ADDENDUM NUMBER 1

**Witkin-Marcus Residence
39 Richard Street
Milford, Connecticut**

Project Number 1252

4th of September 2014

Sheet Number:
SK1

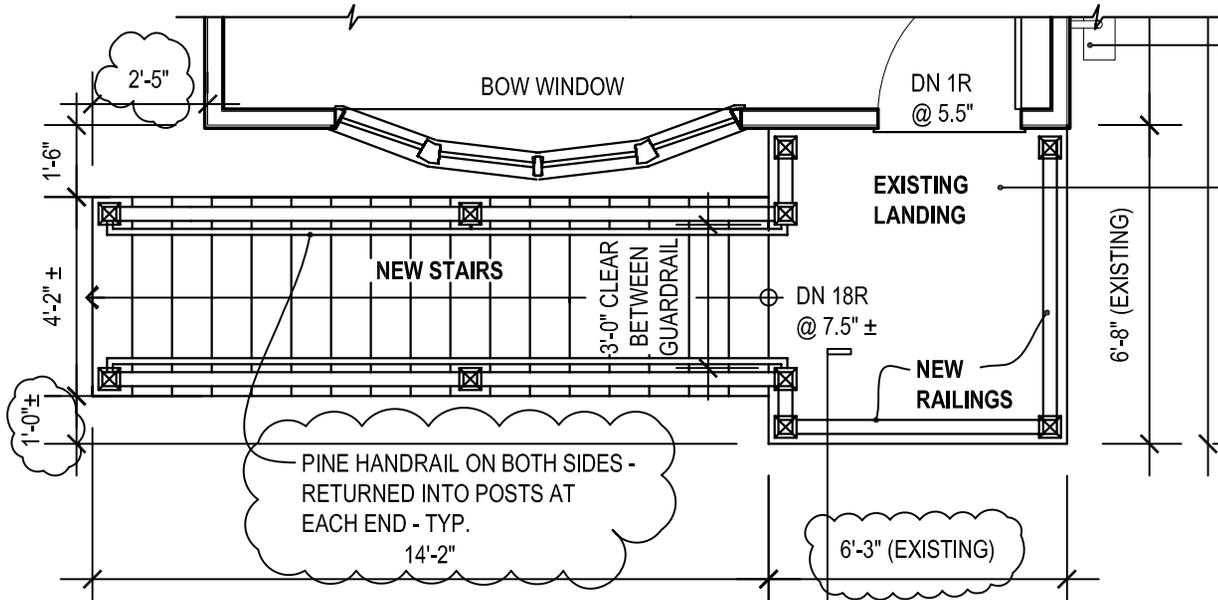
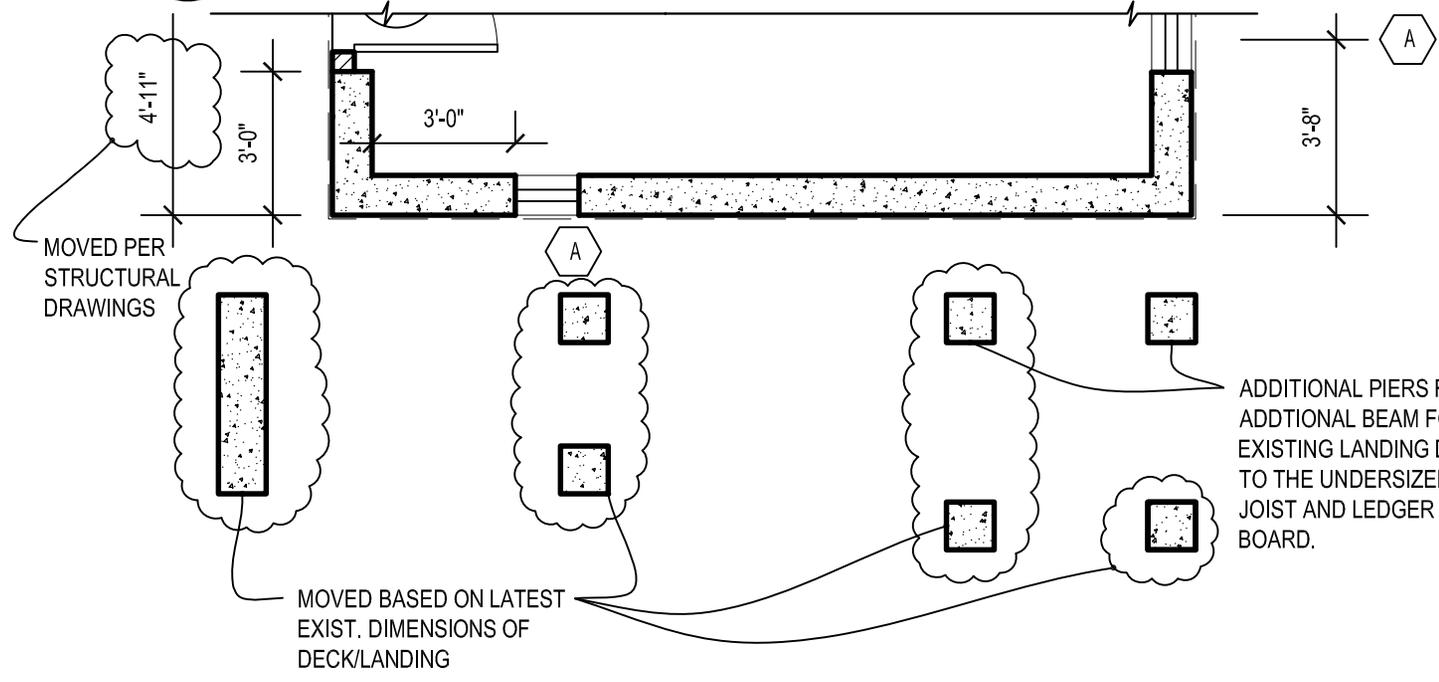
12	SK1 and SK1.1	Clarification – Front wood deck/platform shall remain and be “lifted” to new elevation as indicated on Drawings. Install new supports/footings as required and new guardrail. See SK1 and SK1.1 Drawings (dated the 4 th of September 2014) for additional information.
13	SK4	Change – Concrete slab elevation in Crawl Space to be raised 6” as indicated in SK4 Drawing (dated the 4 th of September 2014) and included as part of this addendum.
14		Clarification – Asbestos Containing Materials are present in the Joint Compound on the Second Floor. They do not have to be remediated. There is no work proposed on this level.
15		Clarification – Lead Painted Components are present on the ceilings and under the wood siding (existing bead board material). Remediate the lead paint only where the existing bead board material is removed and new sheathing material is installed – along base of house.

Sheet Number:
SK2

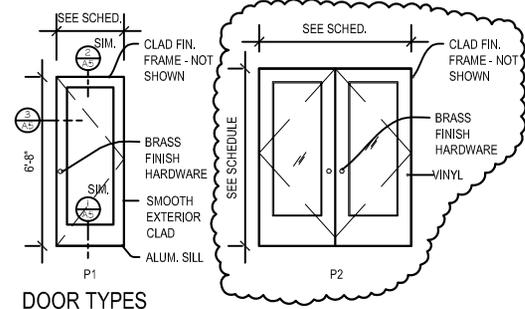
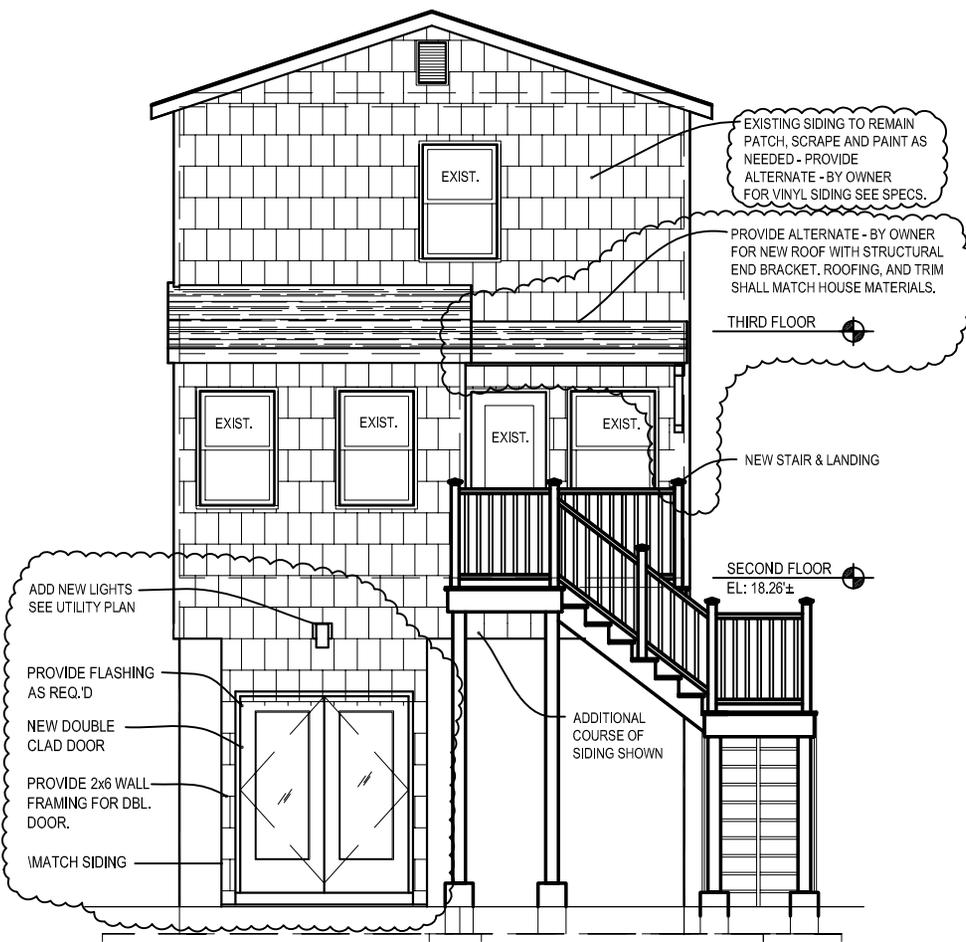
See attached Specification Section 07460 – Vinyl Siding for additional information.
5	Section 01230 DWG U1	Add Section 01230 – Alternates – 3.1 Schedule of Alternates – Add 3.1.C – Provide alternate pricing for the installation of a Gas Valve/Connection in Crawl Space. Price the installation of a valve with shut off on the newly installed gas line in the Crawl Space. Valve is for future use. See attached U1 Drawing (dated the 4 th of September 2014) for location and additional information.
6	Section 01230 DWG U1	Add Section 01230 – Alternates – 3.1 Schedule of Alternates – Add 3.1.D – Provide alternate pricing for Rough Plumbing (only) to serve Utility Sink in Crawl Space. Utility sink to be installed in the future and is not part of this Contract. See attached U1 Drawing (dated the 4 th of September 2014) for location and additional information.
7	Section 01230 SK2, SK2.1 and SK2.3	Add Section 01230 – Alternates – 3.1 Schedule of Alternates – Add 3.1.E – Provide alternate pricing for Roof over rear Entrance Door; include support bracket at end of roof, all framing, roofing materials and flashing – Per the attached SK2, SK2.1 and SK2.3 Drawing (dated the 4 th of September 2014).

8	Section 01210	Add Section 01210 – Allowances – Included with this Addendum is Section 01210 – Allowances. Include the line items and amounts listed as part of the base bid.
9	Drawing A2 and A3 SK2 and SK2.2	Delete reference to Garage (Overhead Door) into Crawl Space. Add pair of French Doors (similar to door on Left (West) Elevation – 3'-0" x 6'-8" (Pair of Type P1 Doors). See the attached SK2 and SK2.2 Drawings (dated the 4 th of September 2014) for additional information.
10	SK3 and SK3.1	Clarification – Remove bottom two courses of Wood Siding around entire building – Install new plywood as indicated in Detail 2/A4 – Provide new Wood Siding 3 Courses or reuse existing (removed siding) – See Item #11 for additional information. See attached SK3 and SK3.1 Drawings (dated the 4 th of September 2014).
11		Paint House - Paint entire house under Base Bid once the new wood siding is installed – Color to be similar to the existing – Include scraping of loose paint, one coat of primer/ sealer and one coat latex finish.
